**CALIFORNIA COASTAL COMMISSION**

**COASTAL DEVELOPMENT PERMIT APPLICATION  
REGULAR CALENDAR**

**Application number** ..... 3-00-067

**Project location** ..... Monterey Bay Coastal trail adjacent to Lighthouse Avenue, City of Monterey, Monterey County

PRESIDIO CURVE BICYCLE /  
PEDESTRIAN TRAIL WIDENING  
FEDERAL AID PROJECT NUMBER: CAL-80-0000  
PLAN SHEET

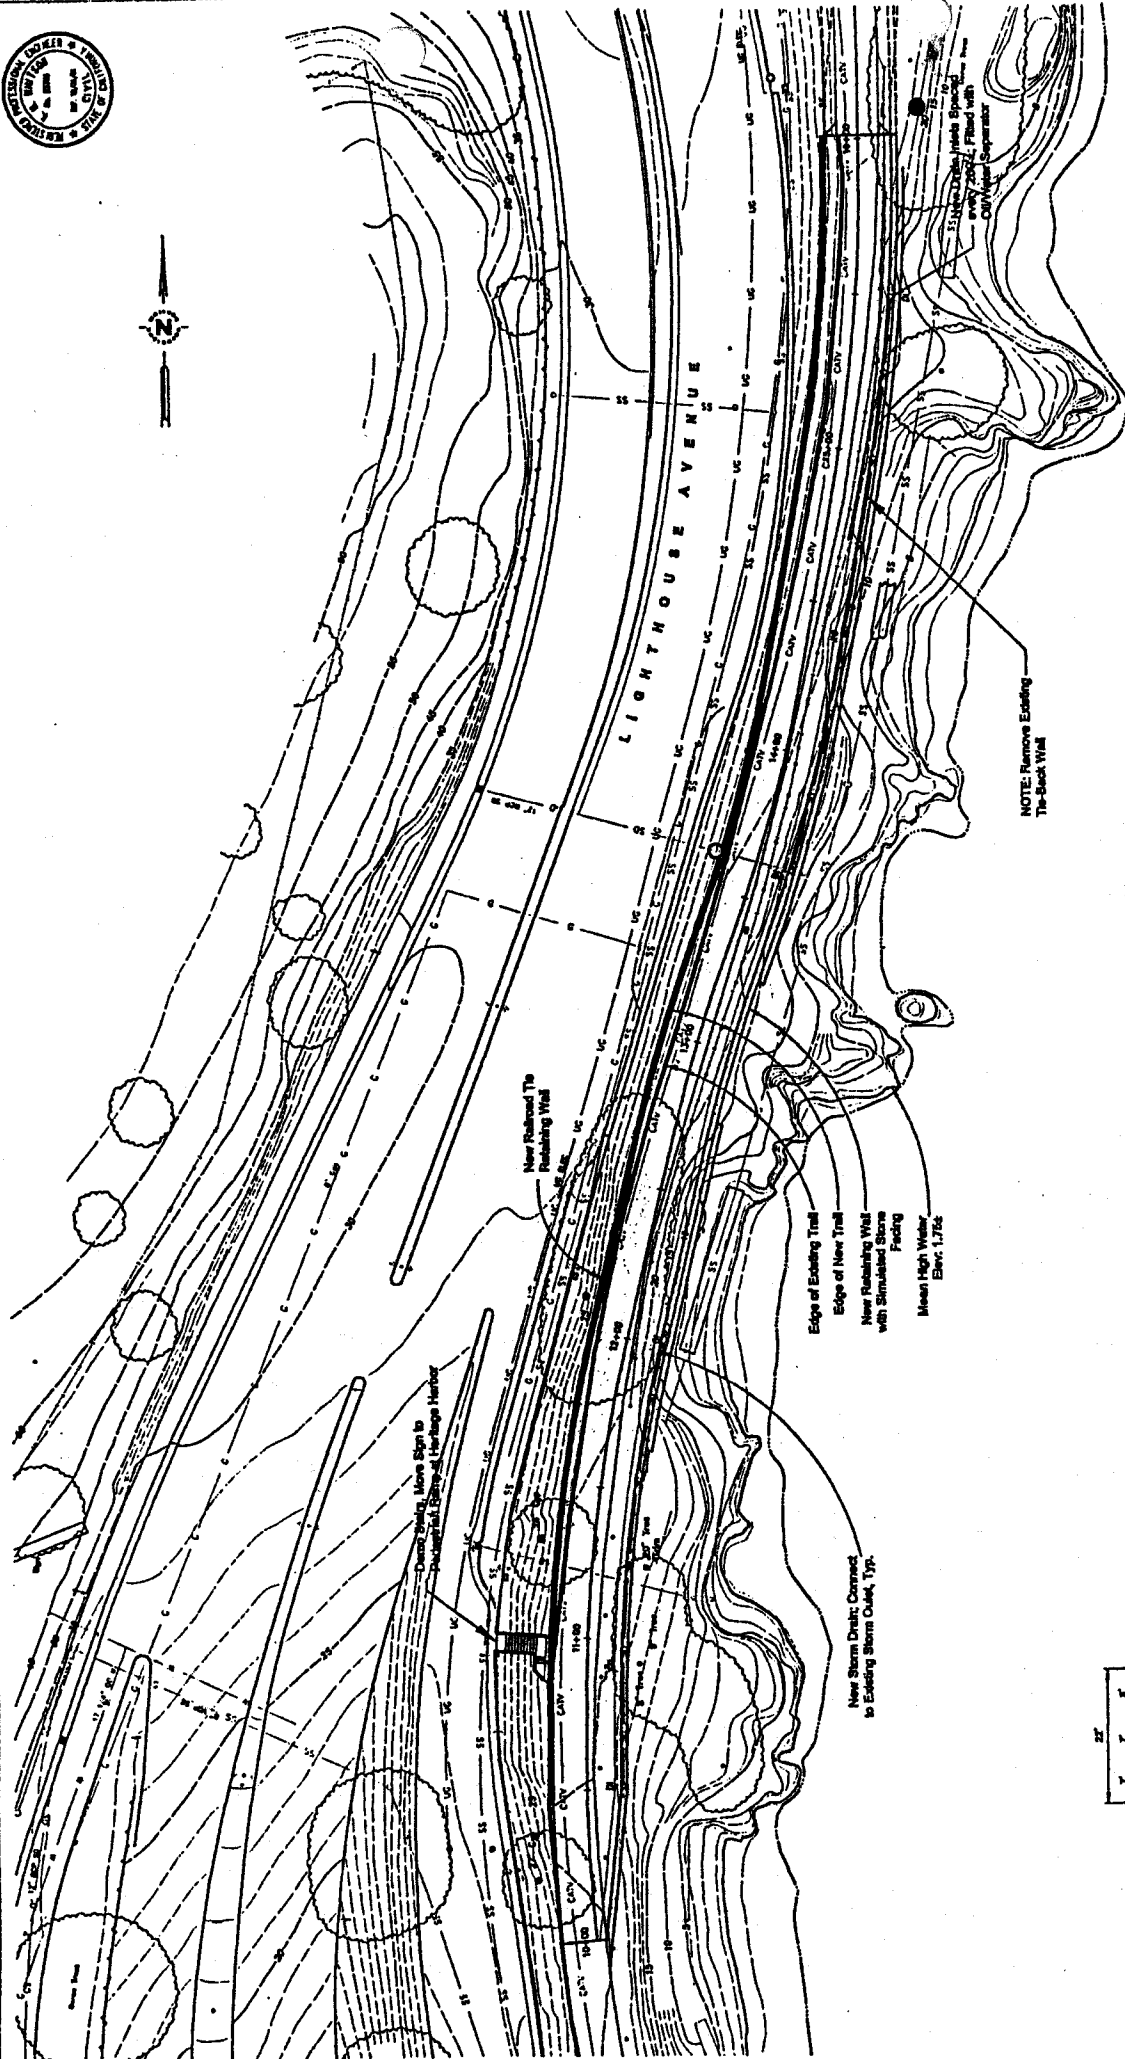
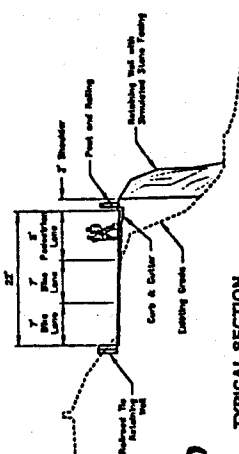
As currently designed, the City's proposed 22 foot width is not necessary to provide appropriate public access in light of the shoreline structure concerns raised by the project. First, although there is little systematic practice in the design and building of recreational trails, particularly those that accommodate both pedestrian and bicycle access (if not other "wheeled users"), there is considerable support for trail widths and designs that are both less than 22 feet and that still provide adequate access. For example, Caltrans design standards for two-way bike paths recommend a minimum width of just over 8 feet and a width of just over 11 feet for such paths in high use situations. In contrast, the City's proposal would allow for 14 feet for the two-way bikepath component. Even assuming a high use scenario, which is appropriate in this case, the total trail width would be closer to 19 feet, assuming the 8 foot pedestrian trail width.

trail to 16 feet total paved width (plus a two foot shoulder) in those locations where shoreline retaining walls are necessary. Although the City has proposed a uniform width for the entire length of the trail to maximize access opportunities, it is not unreasonable to pull the trail in at certain locations to protect competing resources. In this way the requirements of Section 30235 may be met, while allowing for the provision and enhancement of a significant access resource. It should be emphasized again that overall, this approach is consistent with Coastal Act Section 30214 which states in relevant part:

In conclusion, as conditioned to limit the width of the trail to 16 feet total paved width in locations where retaining walls are necessary, and to align the trail as far inland as is feasible, the proposed redevelopment of the Monterey coastal trail is consistent with Section 30235 of the Coastal Act.

1. **Revised Plans. PRIOR TO ISSUANCE OF THE COASTAL DEVELOPMENT PERMIT,** the permittee shall submit to the Executive Director for review and approval two copies of revised plans that show (1) the paved portion of the widened trail to be no more than 16 feet in width in those sections where retaining walls are required; and (2) the trail aligned inland to the maximum extent feasible. At no point shall the paved portion exceed 22 feet in width.

Ex 4  
3-00-067

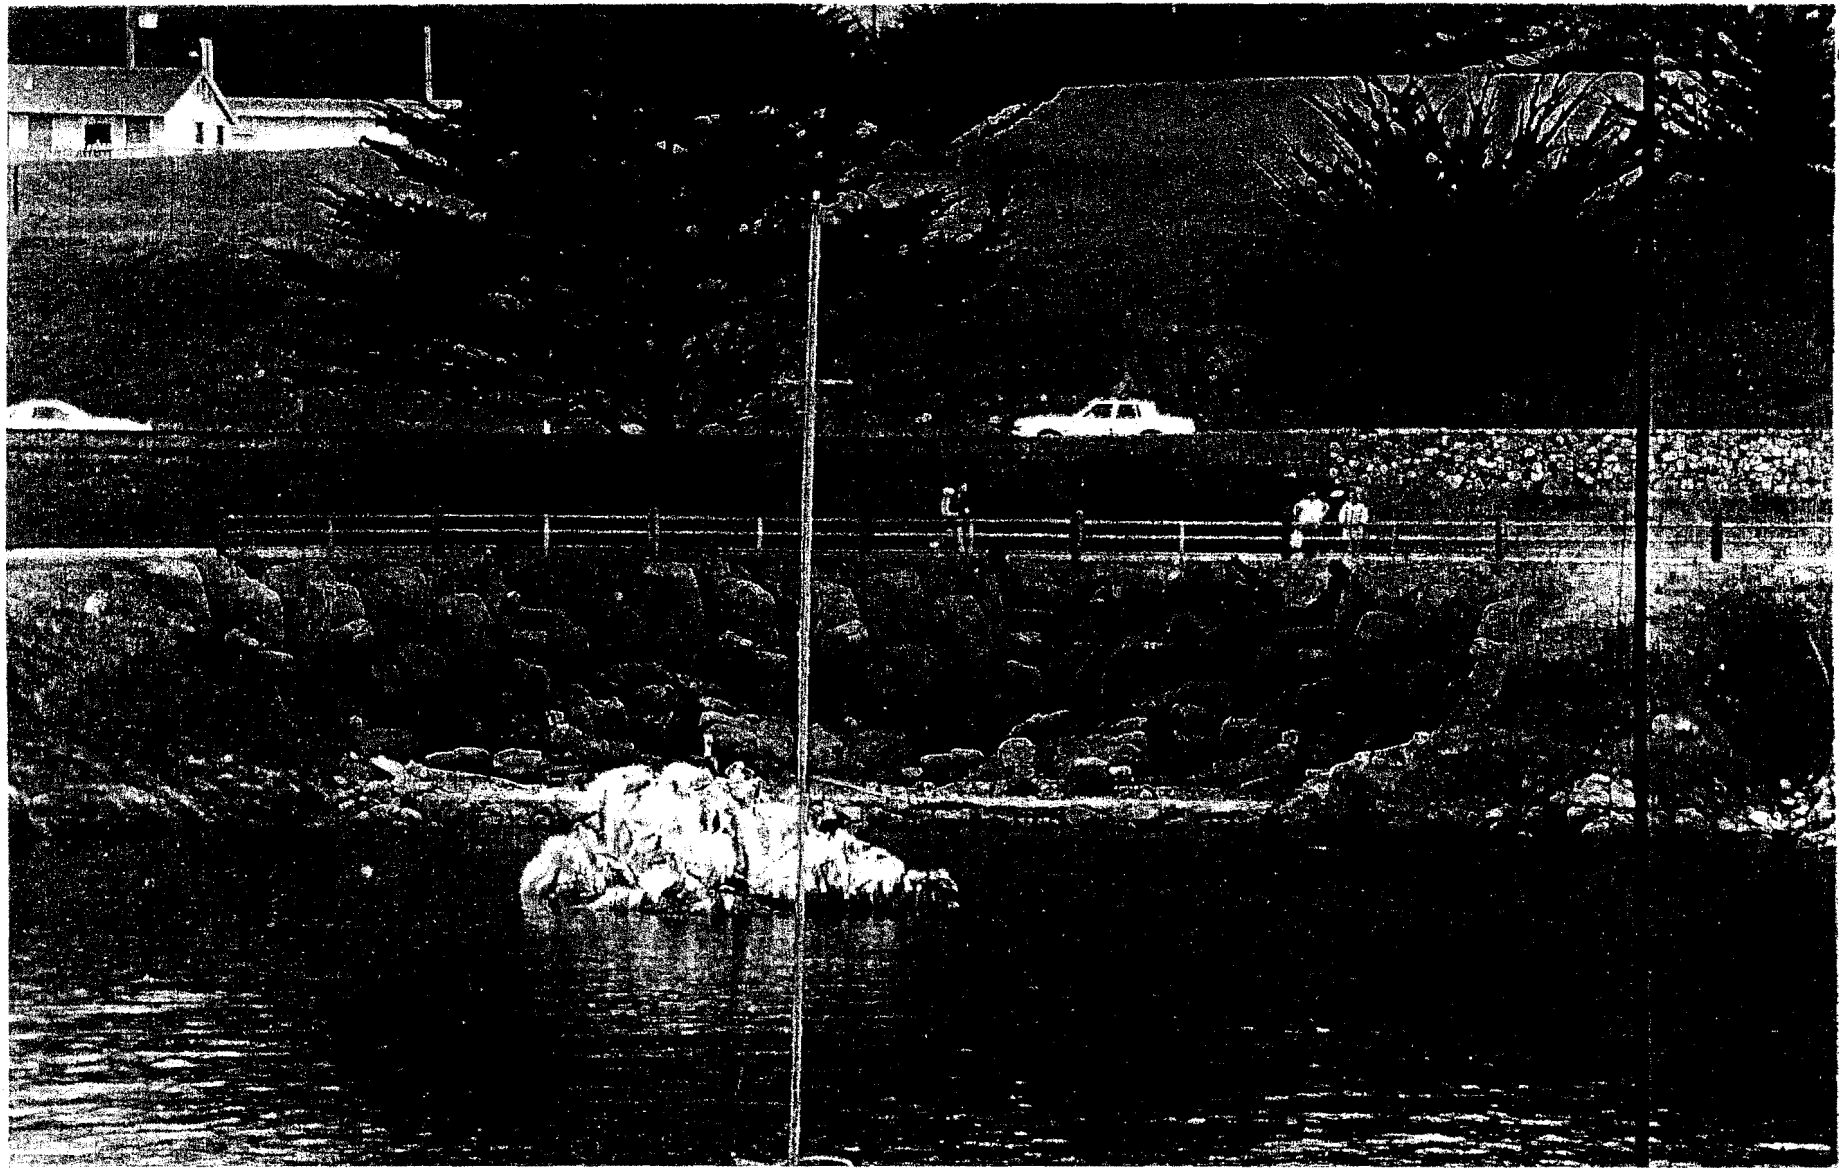
The City proposes to construct the retaining walls with a simulated stone face, so that they would appear as if they were a natural part of the granite bedrock. The walls would be visible from Fisherman's Wharf and the harbor. The proposed method of treating the face of the walls would provide a more natural look than would concrete or wood and would not detract from the setting. In general, the proposed use of simulated stone will mitigate for the visual impacts of the retaining walls. It is important, though, that such simulated stone be designed and implemented in a way that most replicates a natural structure. It is not clear from submitted materials whether the project has yet been designed in sufficient detail to allow for such evaluation. Furthermore, the recommended condition for narrowing the trail where retaining walls are needed would result in a change in the design of the walls. Therefore, the project is conditioned for the submittal of revised photographic representations and revised plans for Executive Director review and approval prior to construction of the project. As proposed, the project is consistent with Coastal Act policies 30251 and 30253 regarding public views.

3. **Visual Resource Protection. PRIOR TO COMMENCEMENT OF CONSTRUCTION,** the permittee shall submit to the Executive Director for review and approval revised visual

representations of the proposed retaining wall construction that illustrate the use of materials and designs that mimic, to the maximum extent feasible, the surrounding natural environs.
